Indian Standard

REFILLABLE SEAMLESS STEEL GAS CYLINDERS— SPECIFICATION

PART 2 QUENCHED AND TEMPERED STEEL CYLINDERS WITH TENSILE STRENGTH LESS THAN 1 100 MPa (112 kgf/mm²)

AMENDMENT NO. 1 MARCH 2007 TO

FIG. 6 TYPICAL LOCATION OF TEST PIECES

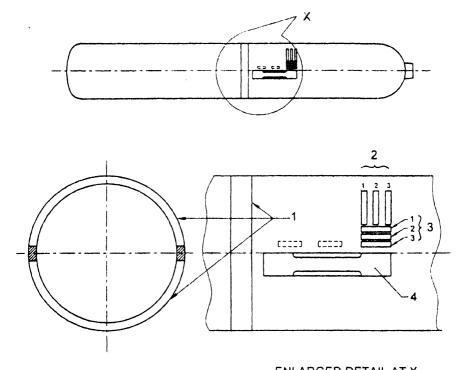
(Page 16, Fig. 6) — Substitute the following for the existing figure:

ENLARGED DETAIL AT X

- 1. BEND TEST PLECES
- 2. TRANSVERSE IMPACT TEST PLECES
- 3. LONGITUDINAL IMPACT TEST PLECES
 (AITERNATIVE POSITIONS SHOWN DOTTED)
- 4. TENSILE TEST PLECES
